## ADDENDUM TO THE CONTRACT DOCUMENTS

ADDENDUM NO. 001
	Project: Solano Community College District Early College High School Portables Project Project Number: 20-012.1
	Date: July 16, 2020

**Addendum No. 001 – The following clarifications are provided and must be added/considered when completing your bid:** Acknowledgement of receipt of this **Addendum No. 001**, is required on the Bid Form. Please clearly note the addendum date and number.

AS2

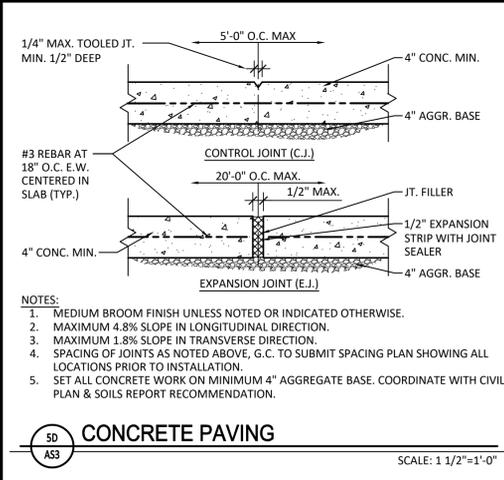
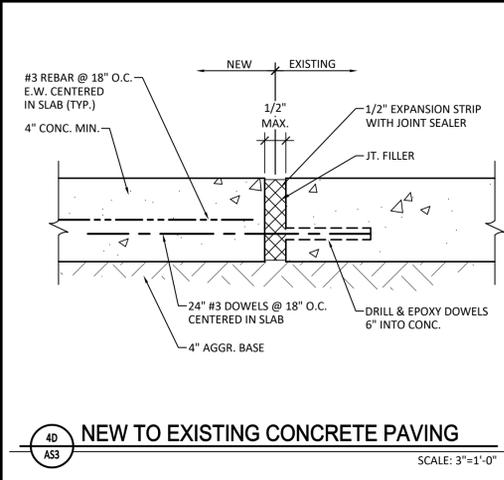
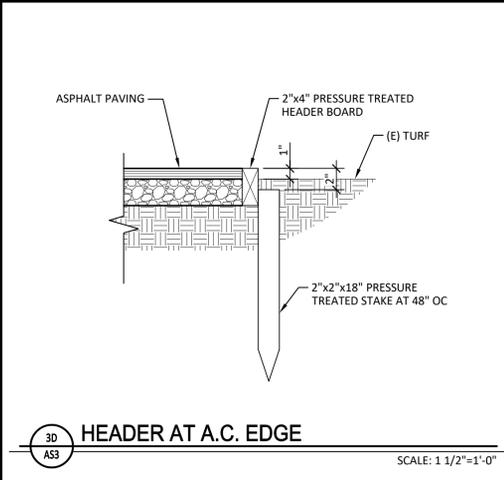
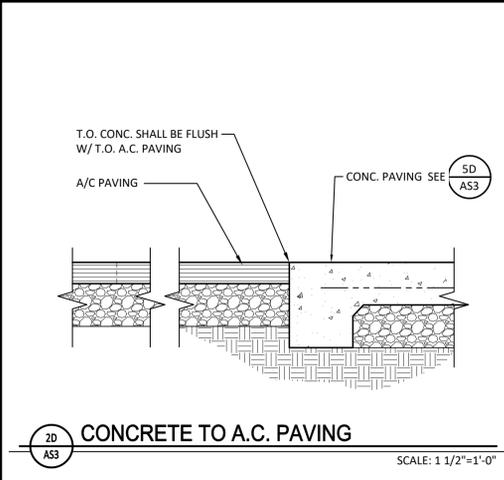
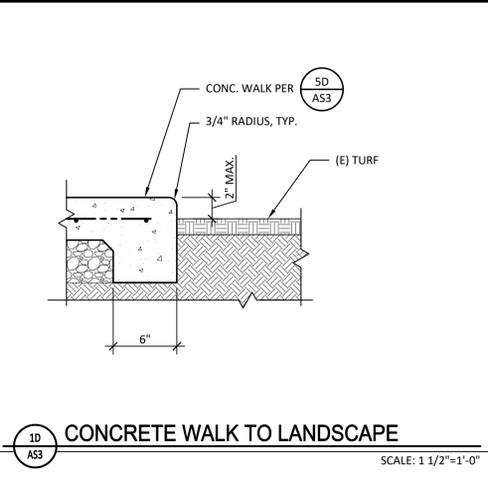
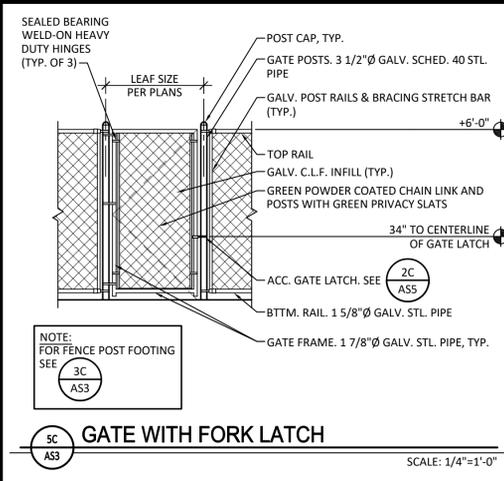
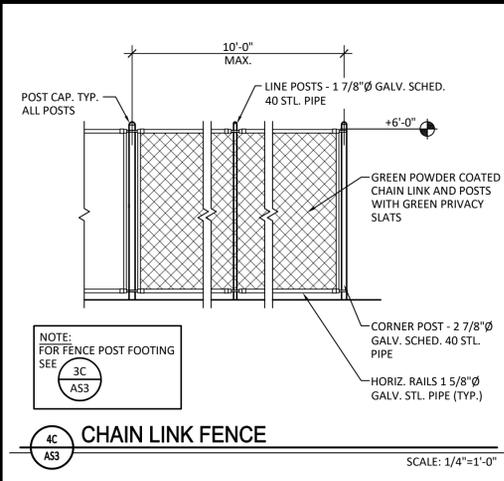
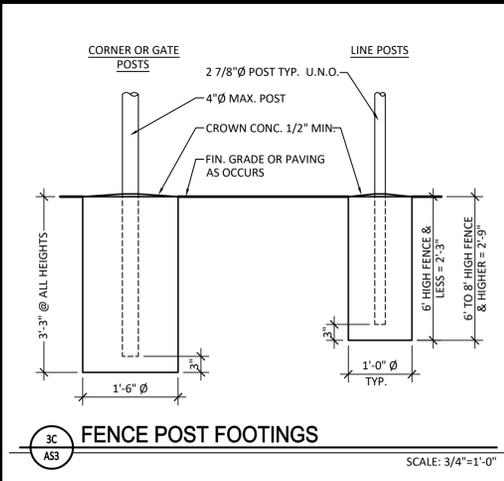
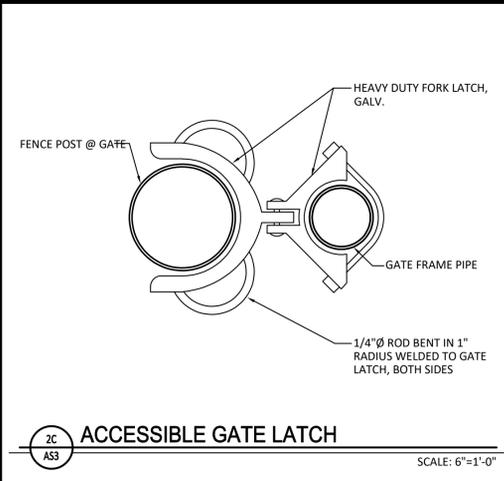
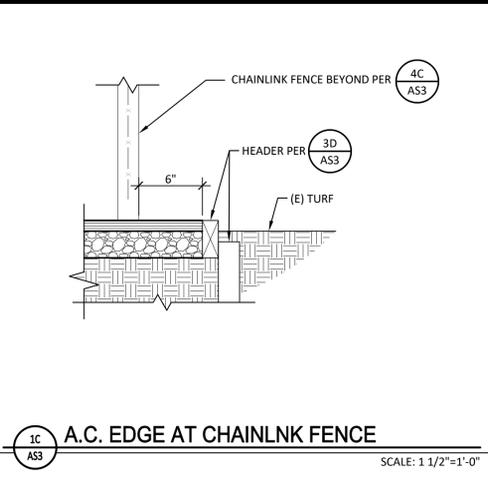
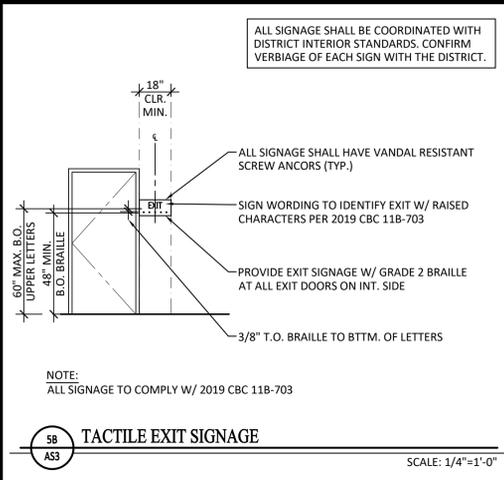
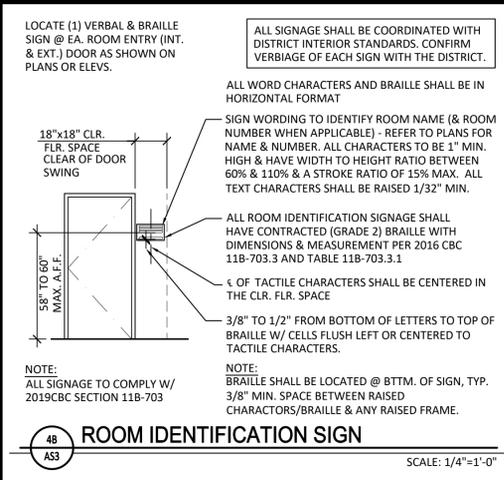
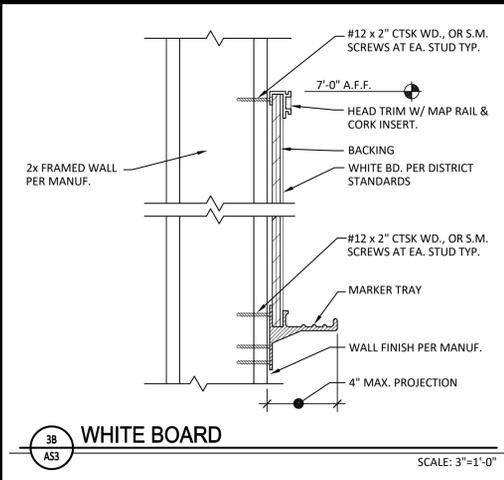
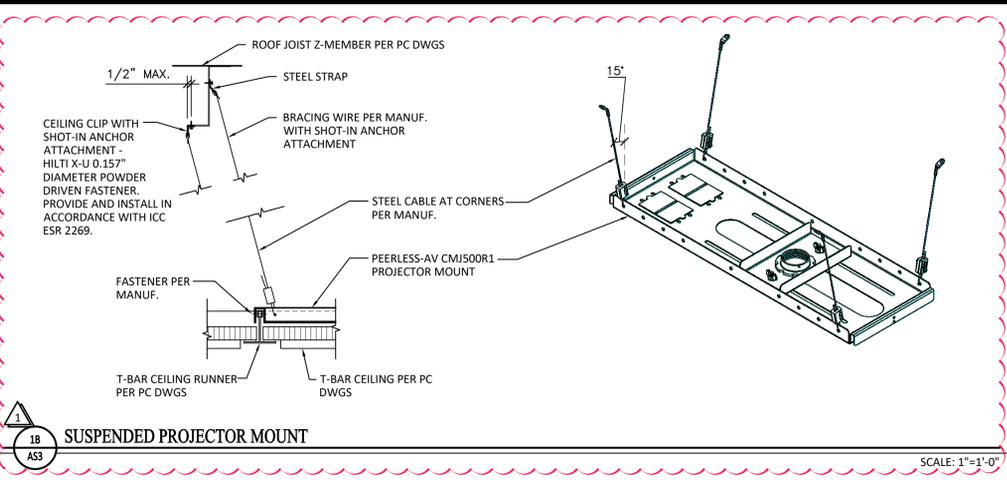
- 1** One projector mount shall be mounted above the ceiling in each classroom. Coordinate Location with the District. The projector mount shall be Peerless-AV CMJ500R1. See sheet AS2 and detail 1B/AS3.

**BUILDING GROUNDING DETAIL**

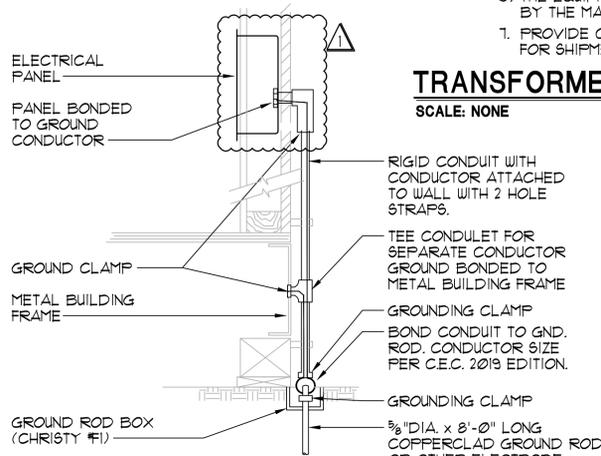
- 2** Revised Building Grounding Detail G, to show building electrical panel as an interior mounted panel. Revised Typ. Conduit to IDF Detail J to show only the 12 strand single mode fiber optic cable in 1-1/2" conduit. See sheet E1.2.

**FIRE ALARM SCOPE OF WORK**

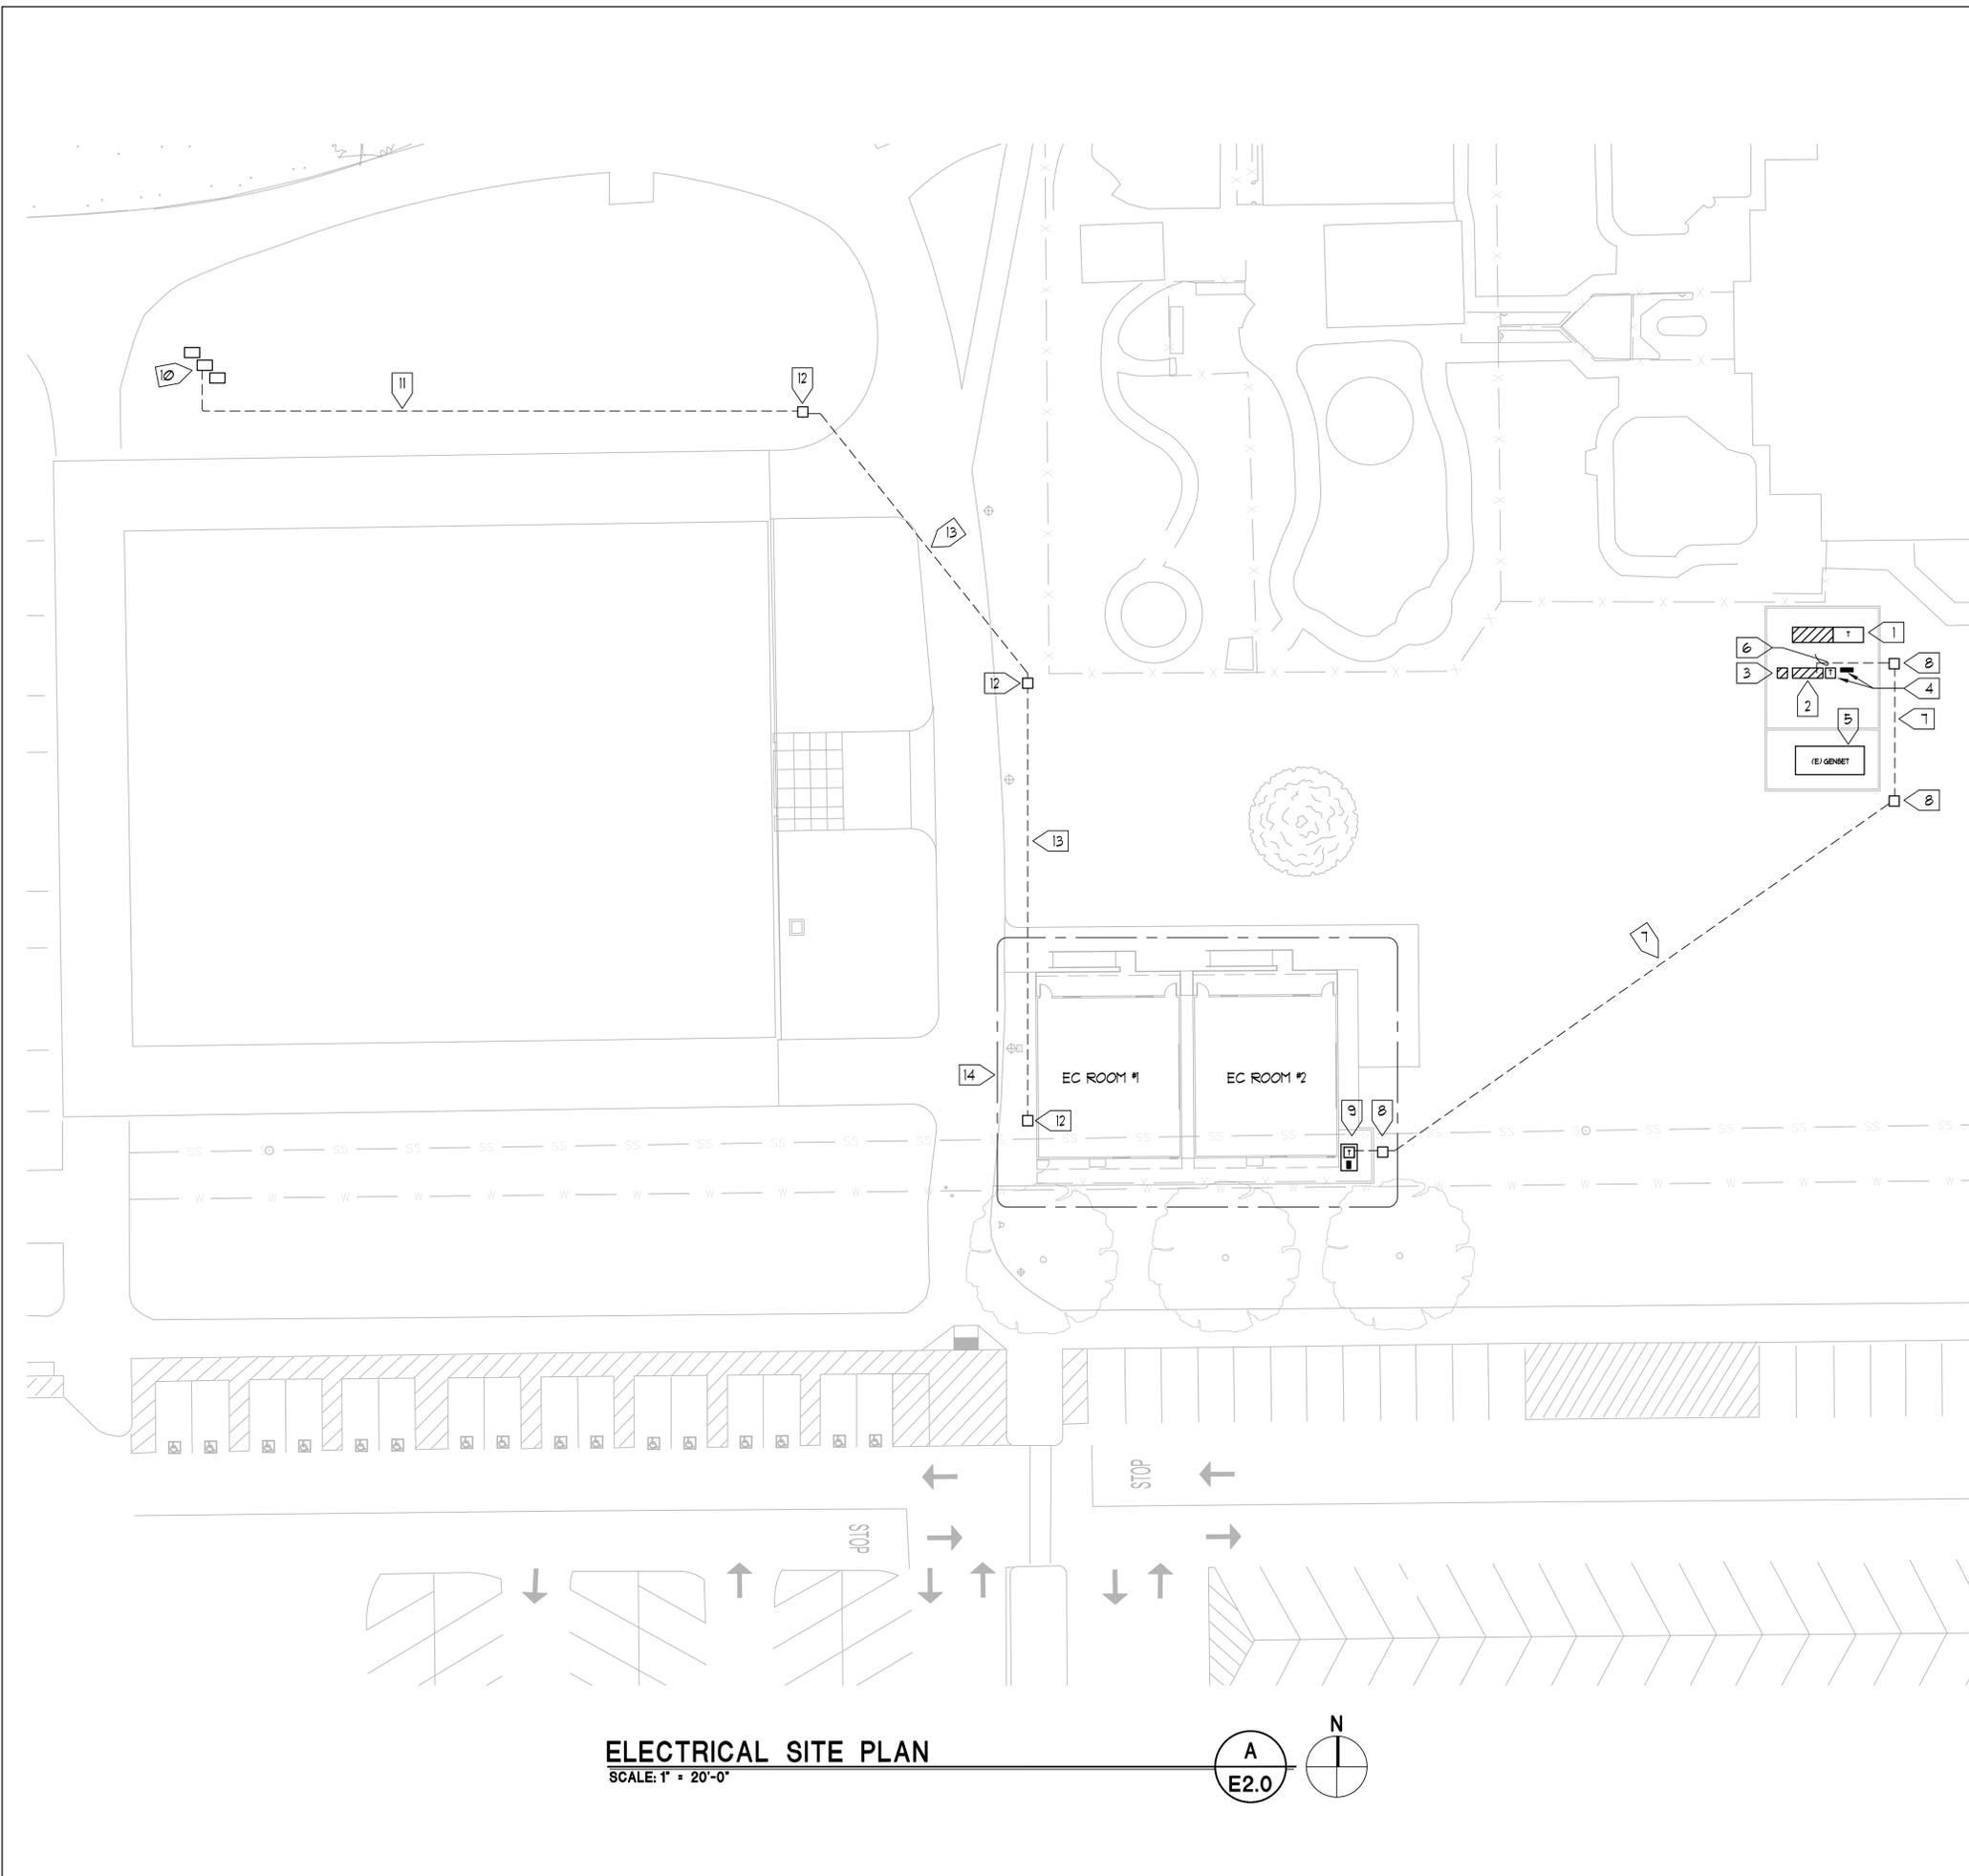
- 3** Revised Fire Alarm Scope of Work. See sheet E1.3.
- 4** Revised Numbered Notes 11 and 13 to have 1" inner duct in lieu of 1-1/2". Added to Numbered Note 6 to direct contractor to x-ray the concrete slab and coordinate conduit routing in field with General Contractor (G.C.), Construction Manager (C.M.) and College District Electrical Department. See sheet E2.0.

THE COLLEGE IS GETTING (2) NEW 36" X 40" PORTABLES WITH A NEW FIRE ALARM VOICE EVACUATION SYSTEM. CONTRACTOR SHALL PROVIDE AND INSTALL A NEW FIRE ALARM SYSTEM FOR A COMPLETE & OPERATIONAL INSTALLATION.

**ENLARGED POWER PLAN**  
SCALE: 1/8" = 1'-0"

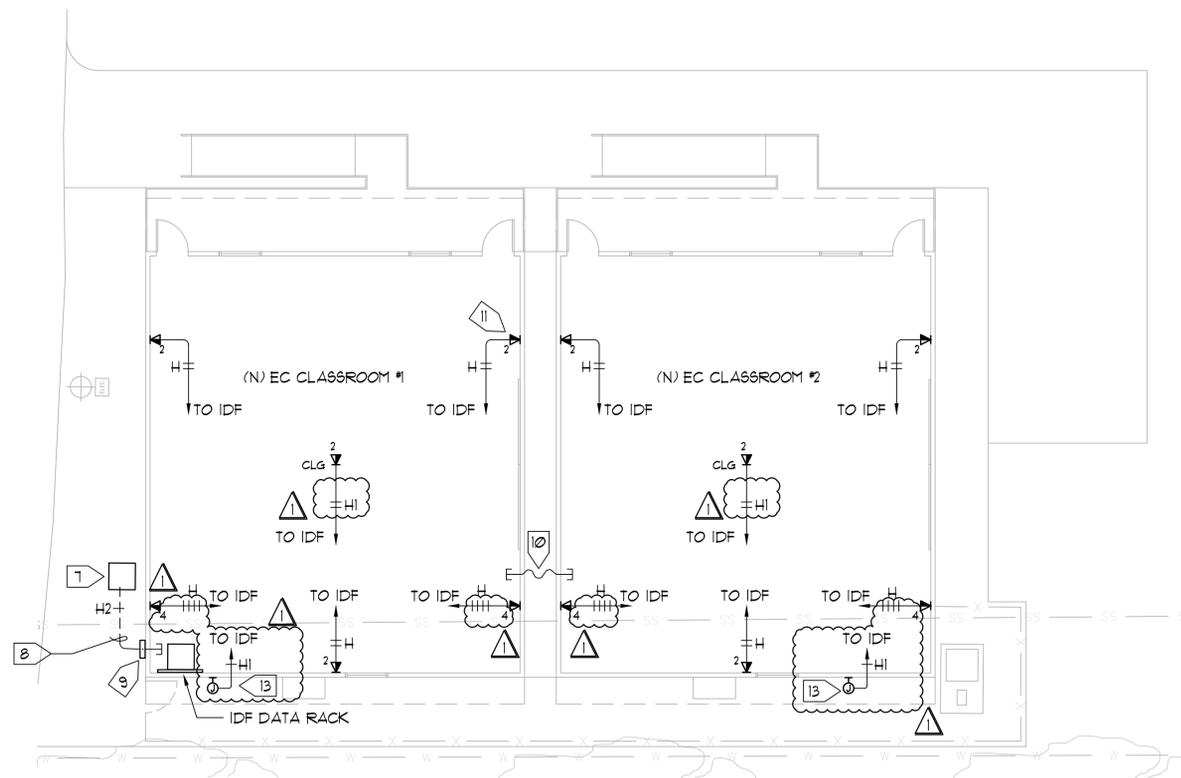
- 5** Revised Enlarged Power Plan A/E3.0. Added a ceiling receptacle for a projector in each Portable Classroom and added Numbered Note 12. Revised Numbered Note 4 informing contractor to install a 20 amp, 120 volt, 1 phase in electrical panel for projector. Revised Numbered Note 6 informing the contractor to provide new IDF cabinet, fan kit and install on plywood backboard per detail C/E1.1. Revised Enlarged Signal Plan B/E3.0. Revised ceiling data cabling to (2) CAT6A cables in lieu of (1) CAT6 and (1) CAT6A cable. Revised the number of data cables at the back of the classroom, on the East and West walls to (4) data cables in lieu of (2) data cables per College District IT Department request. Added an exterior wireless access panel

(WAP) enclosure and CAT6A data cable. Added Numbered Note 13 to address the exterior WAP enclosure. See sheet E3.0.

- 12 MOUNT RECEPTACLE ABOVE CEILING FOR POWER TO PROJECTOR. ROUTE CIRCUIT TO BUILDING ELECTRICAL PANEL AND CONNECT TO 20 AMP RECEPTACLE FOR A COMPLETE AND OPERATIONAL INSTALLATION.

- 13 PROVIDE AN EXTERIOR WIRELESS ACCESS PANEL (WAP) ENCLOSURE WITH DATA CABLE FOR EXTERIOR WAP. TERMINATE DATA CABLE IN ENCLOSURE TO CONNECT TO WAP. COORDINATE EXACT EXTERIOR WAP ENCLOSURE WITH COLLEGE DISTRICT IT DEPARTMENT FOR A COMPLETE AND OPERATIONAL INSTALLATION. CAULK AROUND ENCLOSURE AND SEAL EXTERIOR WALL PENETRATION WEATHERPROOF.
